PLANNING DEPARTMENT

STAFF REPORT

TO: DESIGN COMMISSION
FROM: STEPHANIE DE WOLFE, DEPUTY DIRECTOR, PLANNING
SUBJECT: PROJECT TIME EXTENSION FOR 229 SOUTH MARENGO AVENUE (THIRD EXTENSION) — 21-UNIT MULTI-FAMILY COMPLEX — RM-48 DEVELOPMENT STANDARDS
DATE: MEETING OF MAY 29, 2012

A9

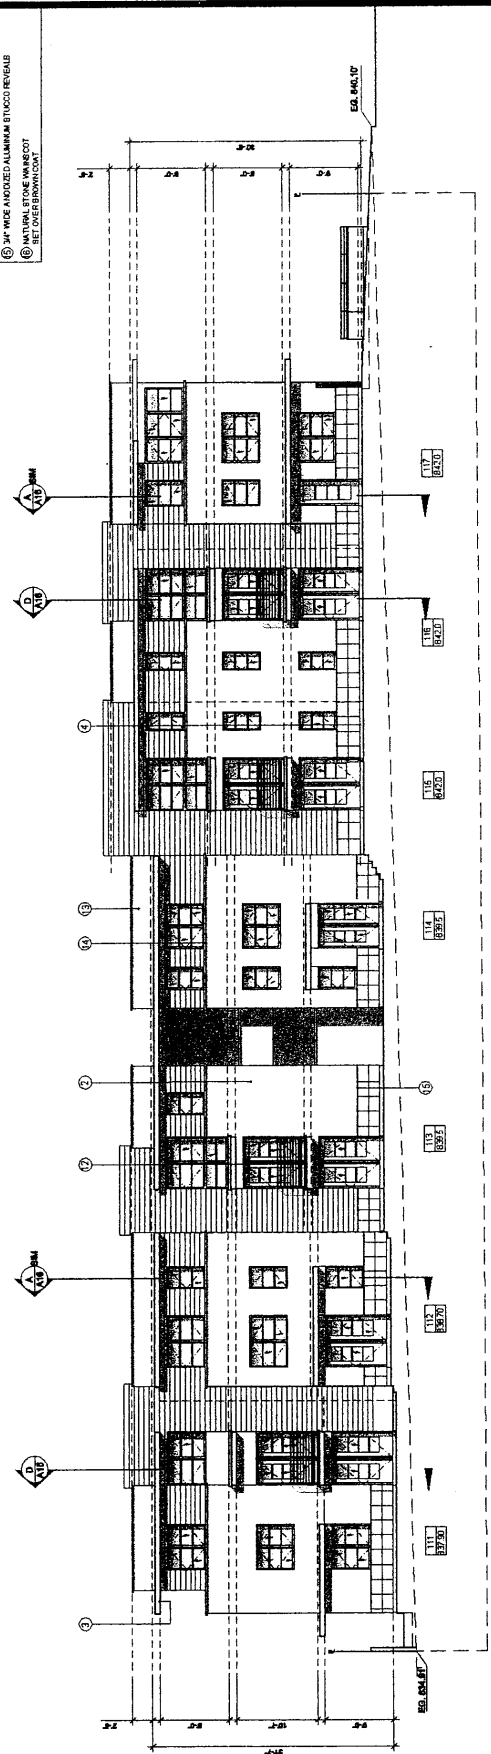
2. The elevation drawings shall be revised to include wood fascias on all eyebrow elements of the building	Wood fascias on eyebrow elements where their adjacent walls are wood will be included for plan check. However, stucco fascias are shown where their adjacent walls are stucco. This will match the stucco fascias of the balcony see A7 & A9.
